Flight Procedures Cover Page	Task Action: FLIGHT CHECK	Task Type: SID	Estimated Chart Date: 07/16/2020	APWS Task ID: 13D8FFCFF295462F98238A6E89FCEB5B	APWS Request ID: 71753E58C1044AC0AFCAF081D149BE10
Procedure: SID DOCTR (RNAV) FOUR WASHINGTON DC KDCA		Enroute: YES	Specialist: Moore, Frank		Agreement Number:
Airport ID: KDCA	Airport Name: RONALD REAGAN WASHINGTON NATIONAL	Airport City: WASHINGTON			State: DC
Facility ID:	Facility Type:	Flight Inspection Remark Type: New FC Slot			
<p><b>Procedure Comments:</b> ACTIVE DATA USED FOR KDCA DEPARTURE DEVELOPMENT. ATC REQUESTED CHANGES. APPROVAL LETTER FOR CLIMB GRADIENT. WAIVER FOR LENGTH OF SEGMENT. CONTACT DAVE TEFFETELLER AT 202-267-5177.</p> <p>10/22/20: THIS IS AN UPDATED COPY OF THE FORM DEVELOPED ON 02/17/20. 1. CHANGED RWY01 VI LEG DIST FROM 1.79 TO .61</p>

<b>PROCEDURE:</b> SID DOCTR (RNAV) FOUR WASHINGTON DC KDCA		<b>AIRPORT NAME:</b> RONALD REAGAN WASHINGTON		<b>AIRPORT ID:</b> KDCA	<b>SPECIAL CONTROL NO:</b> YG-09-112-20
<b>FAC ID:</b> DOCTR4		<b>CITY:</b> WASHINGTON		<b>ST:</b> DC	<b>ORIG CHART DATE:</b> 12/31/2020
<b>DFL TYPE:</b> PROC/D	<b>THIRD PARTY:</b> <input type="checkbox"/> YES	<b>EST. TIME ON SITE:</b> 1.0	<b>REI

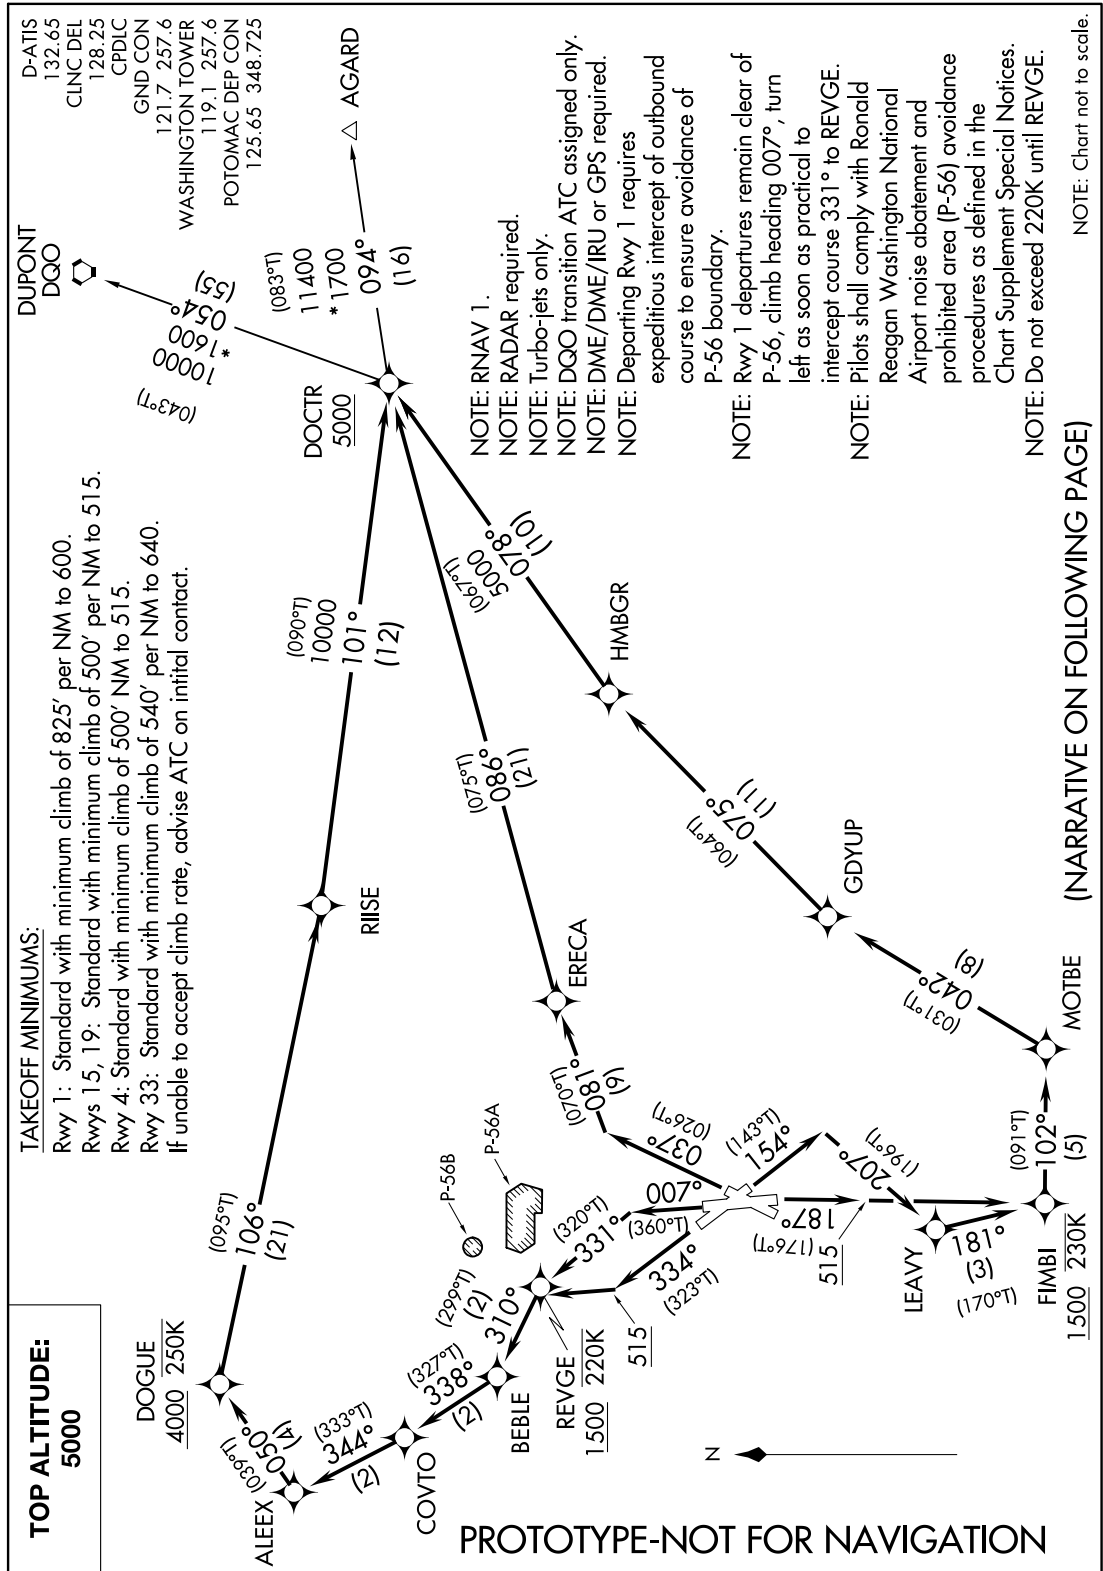
TAKEOFF RWY 1: Climb on heading 007° to intercept course 331° to REVGE, cross REVGE at or above 1500 and at or below 220K, then on track 310° to BEBLE, then on track 338° to COVTO, then on track 344 to ALEEX, then on track 050° to DOGUE, cross DOGUE at or above 4000 and at or below 250K then on track 106° to RIISE, then on track 101° to DOCTR, cross DOCTR at or above 5000, thence . . . .

TAKEOFF RWY 1: Climb heading 006° to intercept course 334° to ADAXE, then on depicted route to DOCTR, thence . . . .

**Figure 1:** The no action alternative flight radar tracks (light blue) versus the proposed actions flight radar tracks (magenta) for the period January 30 - February 5, 2020.

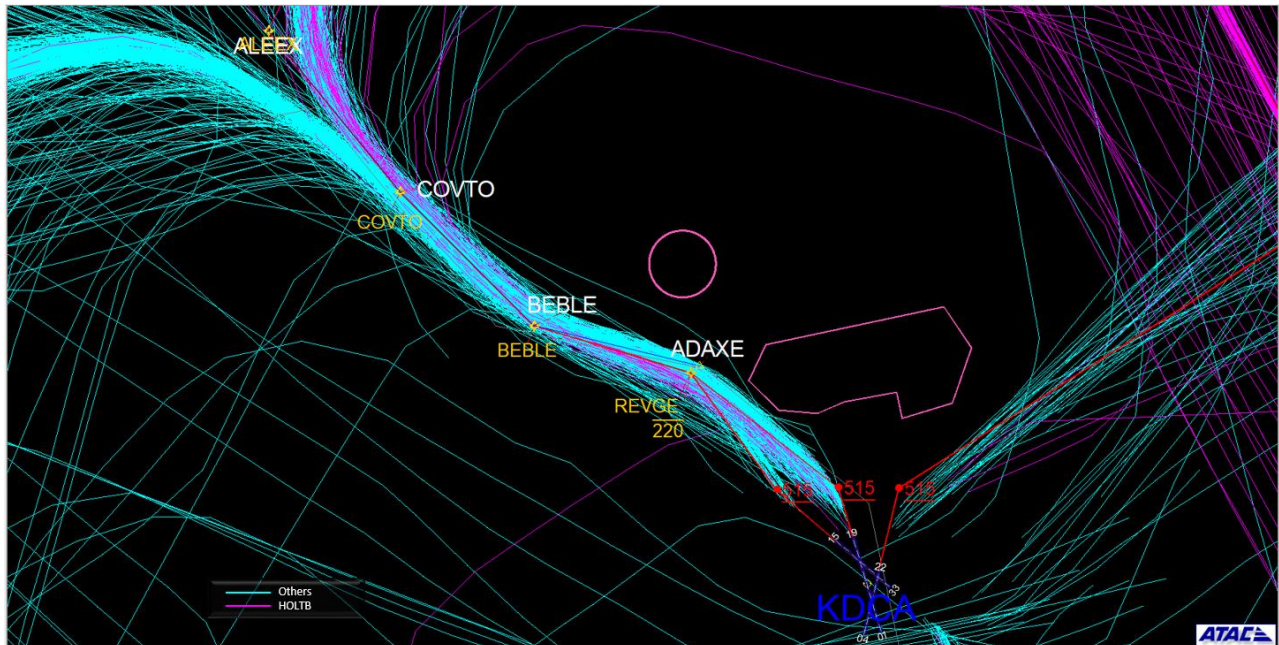
- 1) The following procedures would be amended to replace waypoint ADAXE with REVGE: HORTO4, CLTCH3, JDUBB4, SOOKI5, DOCTR5, REBLL5, WYNGS5, SCRAM6. Refer to **Figure 1**
- 2) In addition to action 1, the following procedures would also replace waypoint FERGE with RGIII: HORTO, WYNGS, REBLL, CLTCH, SCRAM, and JDUBB. Refer to **Figure 2**
- 3) HOLT B1, which was initially adopted for temporary use through July 31, 2020, will be adopted for continued use until it is replaced by AMEEE1, as described below.
- 4) The AMEEE1 procedure will be published and replace the HOLT B1 and BOOCK3, which will be canceled. Refer to **Figure 1**
- 5) To enhance safety and efficiency into the NEC and ACR, the BWI CONLE SID and IAD JCOBY SID will be amended to incorporate the SCOOB transition for aircraft over 18,000 feet AGL. Refer to **Figure 3**

The need for this project is to enhance national security by reducing incursions into P-56 airspace. The shift from waypoint ADAXE to REVGE is expected to reduce incursions by causing aircraft to turn away from P-56 sooner to fly-by waypoint REVGE, which will be located 784 feet southwest. This action was requested by the U.S. Secret Service, which asked the FAA Administrator to formulate a solution to protect the P-56 airspace. This proposed change will affect multiple north-flow aircraft departure procedures, which would replace waypoint ADAXE with REVGE.

**Figure 2:** Flight tracks (blue lines) using FERGI waypoint. The dark blue line is the existing route using the FERGI waypoint. The red line is the proposed route removing FERGI and adding RQRI waypoint. Flight tracks were recorded in August 2019.

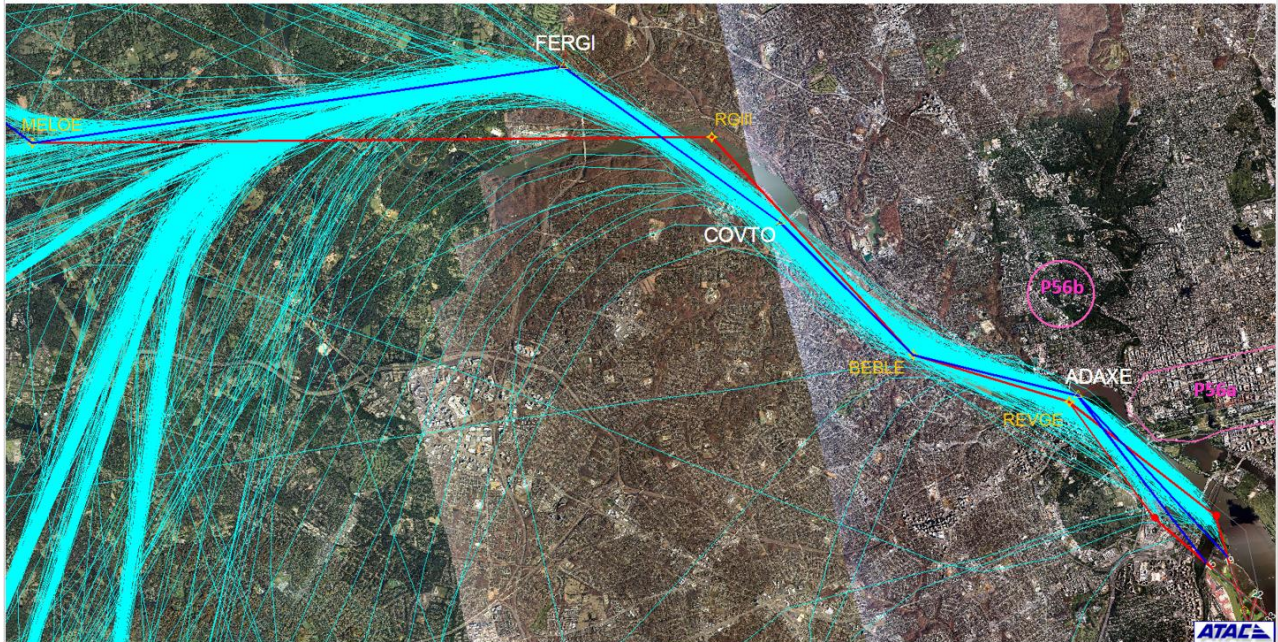
Additionally, the FAA is proposing to remove waypoint FERGI and replace it with a new waypoint, RGIII, which will keep aircraft closer to the Potomac River. The change was requested (following a unanimous vote) by the DCA Community Noise Working Group, a group comprised of representatives from surrounding communities that is focused on noise-related concerns from aircraft operating at DCA. The FAA opened a comment period from May 15, 2020 to June 15, 2020 to allow the public the opportunity to comment on the FERGI waypoint removal; establishment of the AIMEE SID; cancellation of HOLTB and BOOCK SIDs; and, establishment of the the high altitude SCOOB transition. The FAA received three comments which can be reviewed in **Attachment C**. Refer to **Figure 2** to view flight tracks for the removal of waypoint FERGI and the addition of RGIII.

**Figure 3:** Flight tracks (light blue lines) near the proposed SCOOB transition (blue line). Flight tracks were recorded in August 2019.

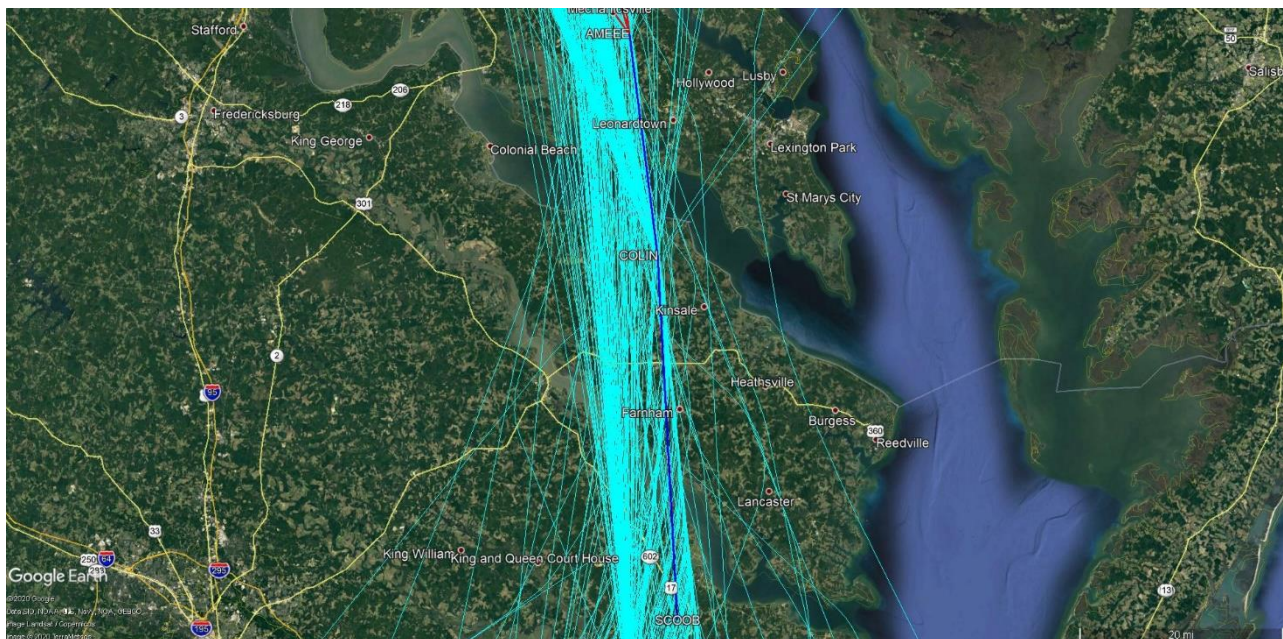
The BWI CONLE and IAD JCOBY SIDs are being amended to establish the SCOOB transition, as proposed for the new AMEEE1, which will be used above 18,000 feet AGL and is not expected to change the existing flight corridor. Refer to **Figure 3** to view the proposed SCOOB transition.
